Subject: **WHITE LINES ON DISPLAY**

Model: **BVM-1310/1315/1910/1912**

Figure 1

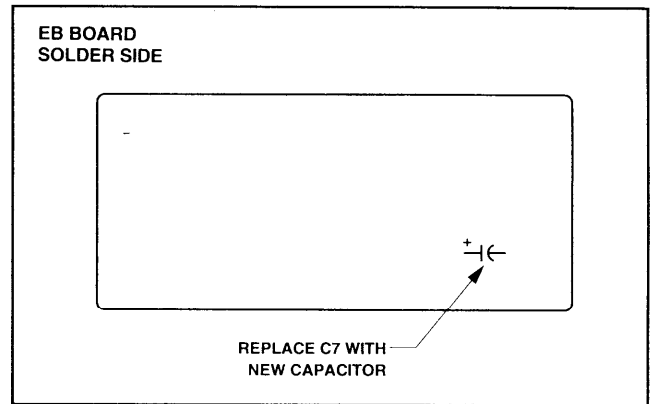
Ripple current may reduce the electrolytic capacitance in the vertical deflection circuit on the EB board, and white lines may appear at the top of the display.

BVM-1315

- Replace capacitor C7 (4.7 μ F, 200V) on the EB board with the new high-ripple current 4.7 μ F capacitor. (See Figure 1.)

Figure 2

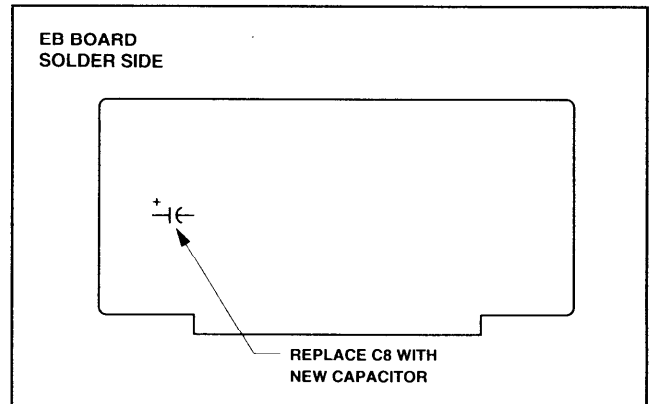
BVM-1310/1910/1912

- Replace capacitor C8 (4.7 μ F, 200V) on the EB board with the new high-ripple current 4.7 μ F capacitor. (See Figure 2.)
